2023 ROADWAY IMPROVEMENT PROJECT

**Brook Hollow Dr, Gordon Ave, Island Rd, London Rd, Main St
SALEM, NH**

ADDENDUM No. 1

January 17, 2023

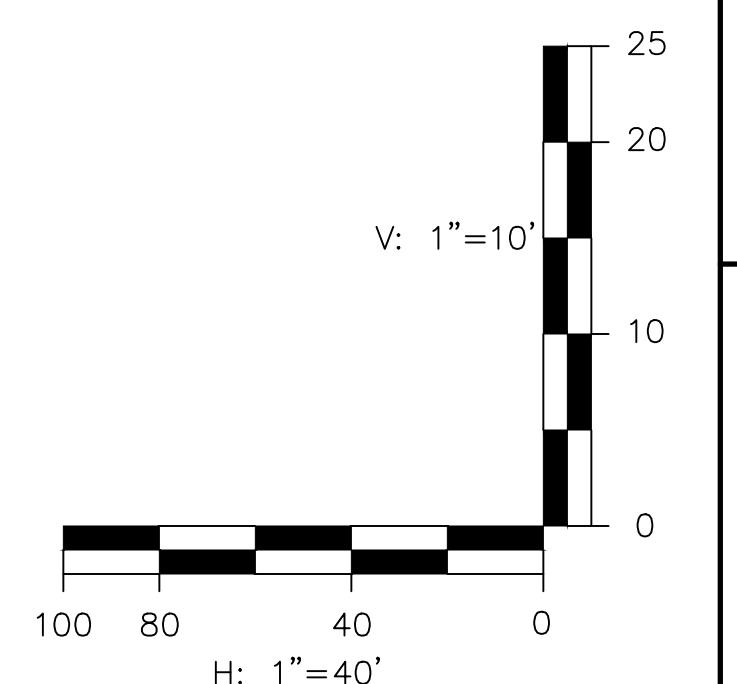
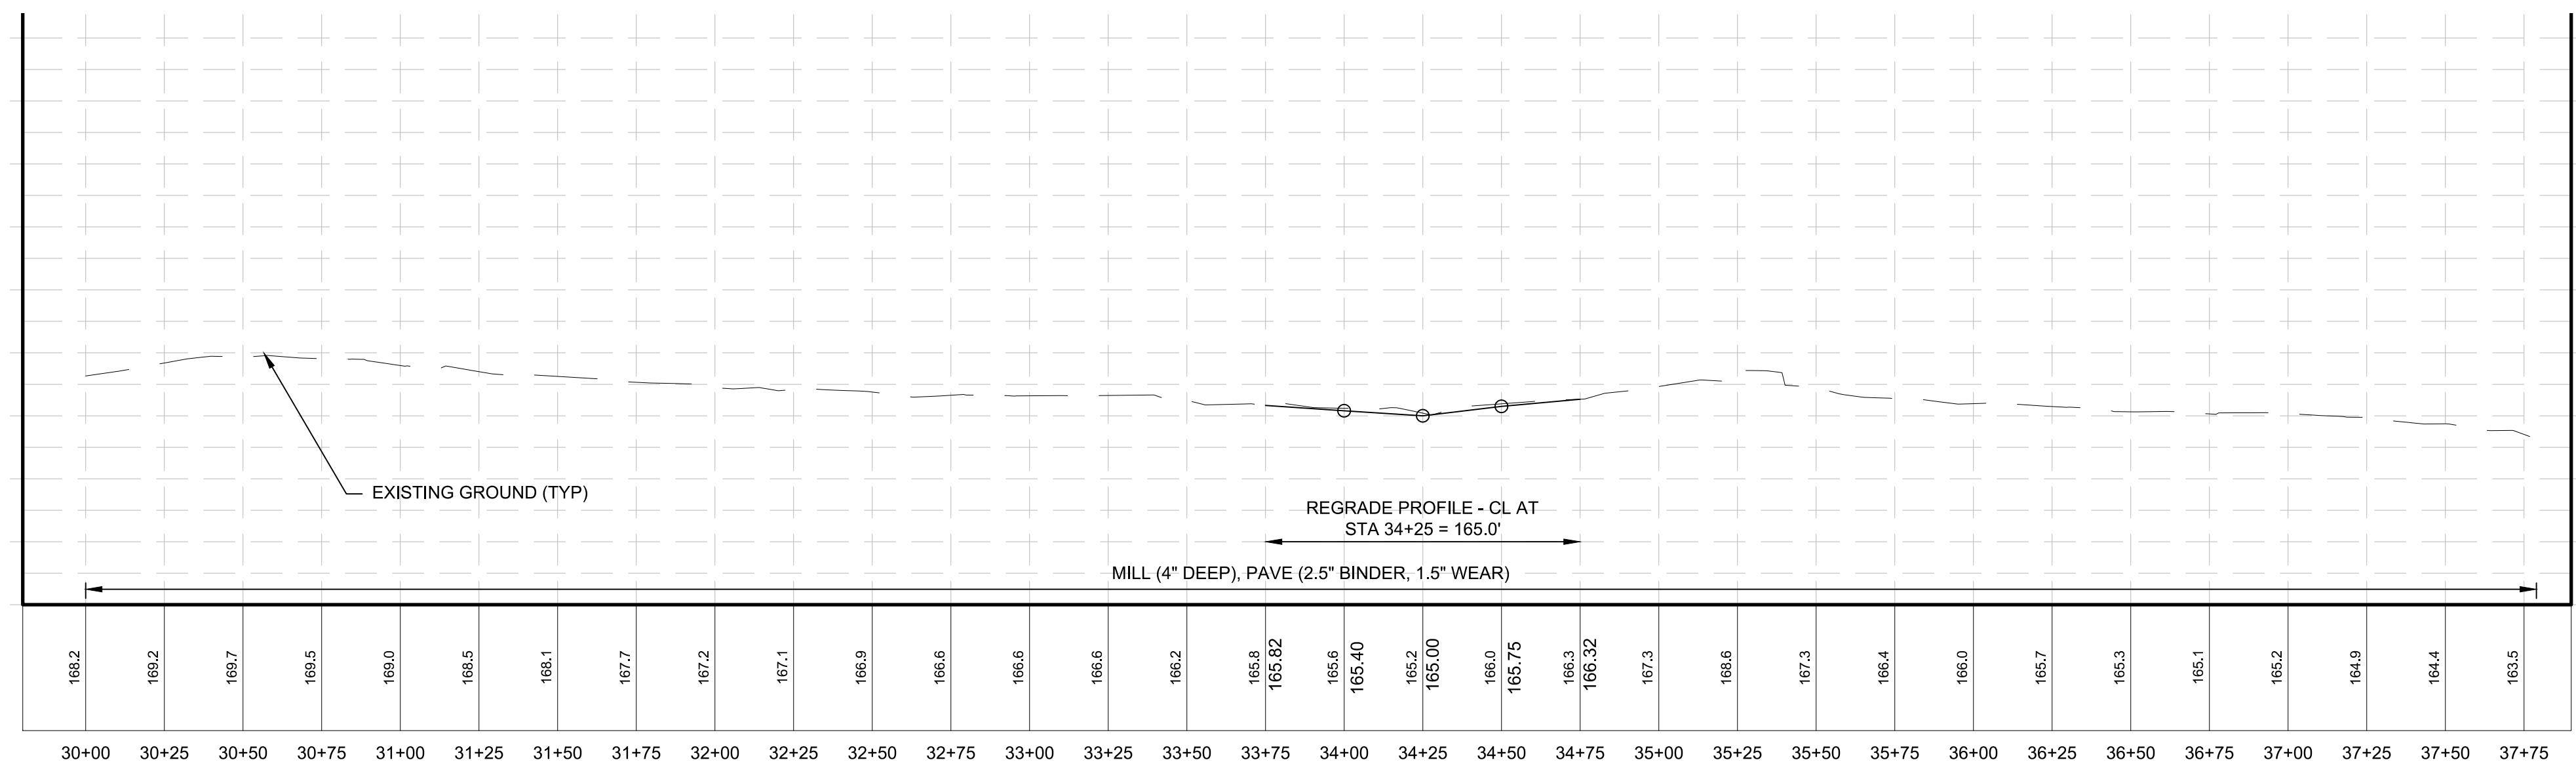
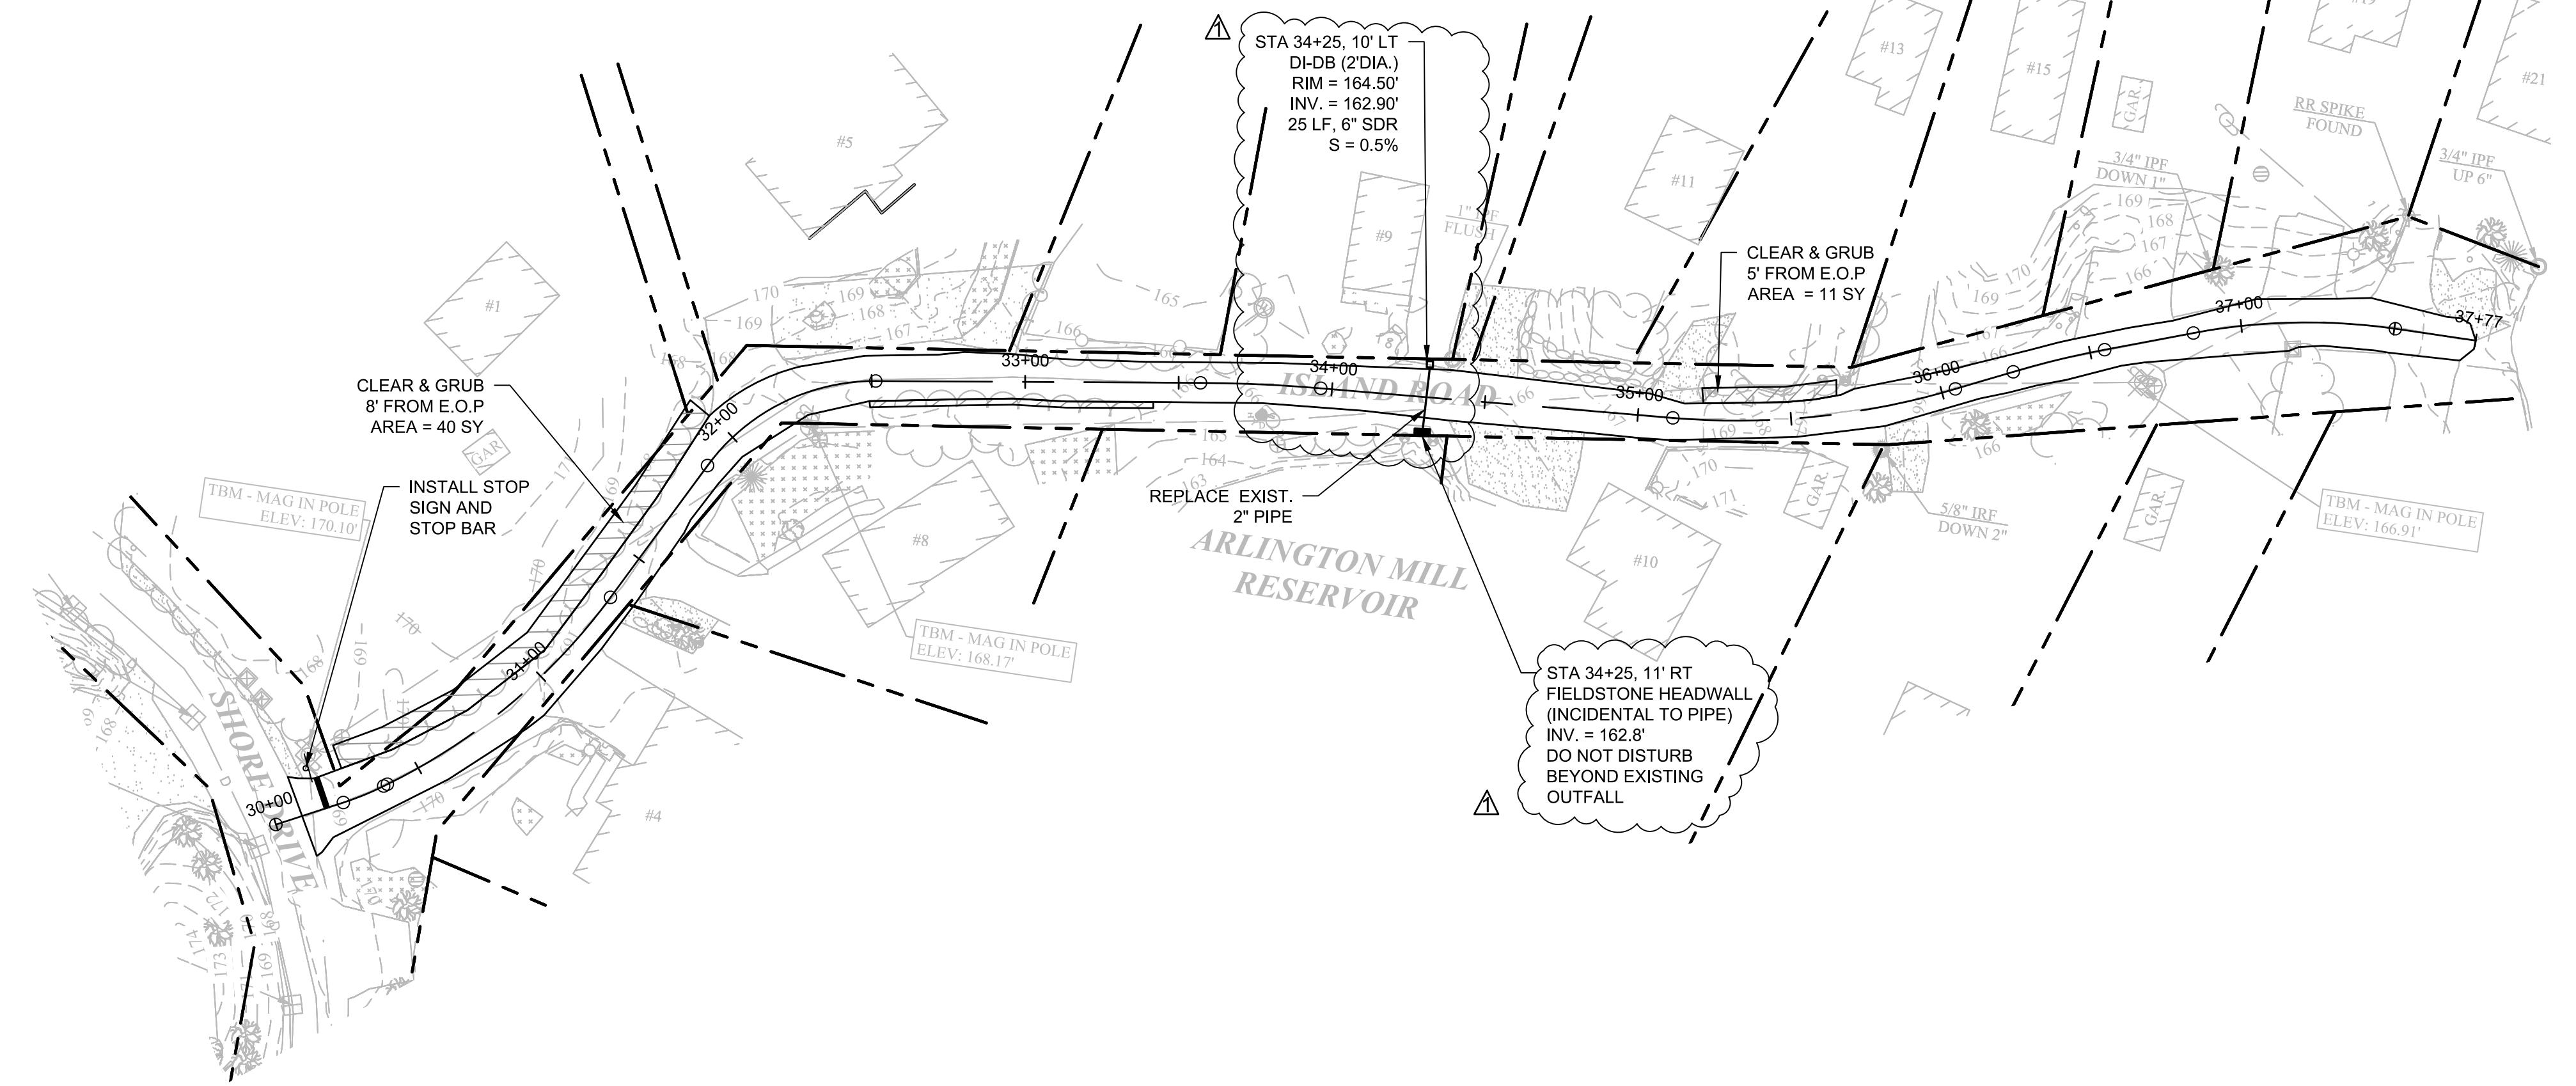
1. Is there a typical section for Island Road?

Answer: No. The road is described on the plan sheet as being 16-feet wide with a 4" pavement section (2.5" binder and 1.5" wearing). The bid items and design account for a full depth 4" deep mill.
